MEYLE No. 514 943 4263/HD  
Reference No. 9434 263  
9434 288

## Engine mount to fit Volvo 850, C 70, S 70, V 70

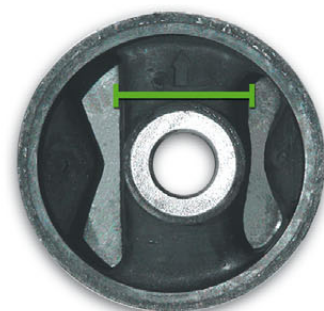
Plastic outer sleeve with large diameter (approx. 61 mm dia. oversize) in relation to the bore (approx. 58 mm).

Aging of the plastic results in loosening of its tight fit in the bore.

Steel outer sleeve with smaller diameter (approx. 58.3 mm dia. oversize) in relation to the bore.

Lasting, tight fit.
